TECHNICAL SERVICE BULLETIN

ISSUE DATE:	6-10-2021
SERVICE BULLETIN SUBJECT:	800 Volt Catalyst 40 Horn Relay Retrofit
VINs or MODELS AFFECTED:	Service Specified Buses
COMPLETE BY:	Next Service Opportunity
SERVICE BULLETIN #:	SC-21-82
LABOR OPERATION CODE:	DE41Z

800 VOLT CATALYST 40 HORN RELAY RETROFIT

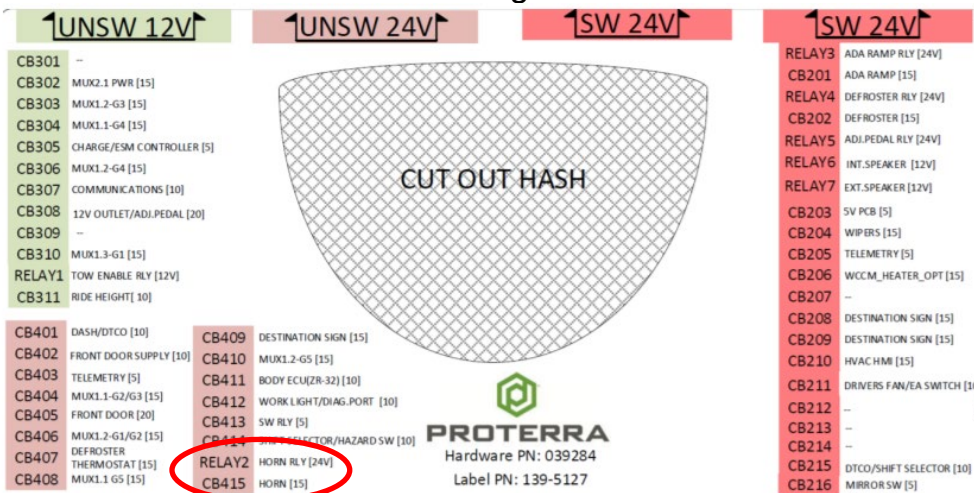
1. Complete the Proterra approved Lockout/Tagout procedure to make the bus safe for work.
2. Using a T-30 Torx Driver, remove the ECAB Panel as shown in the following photograph.
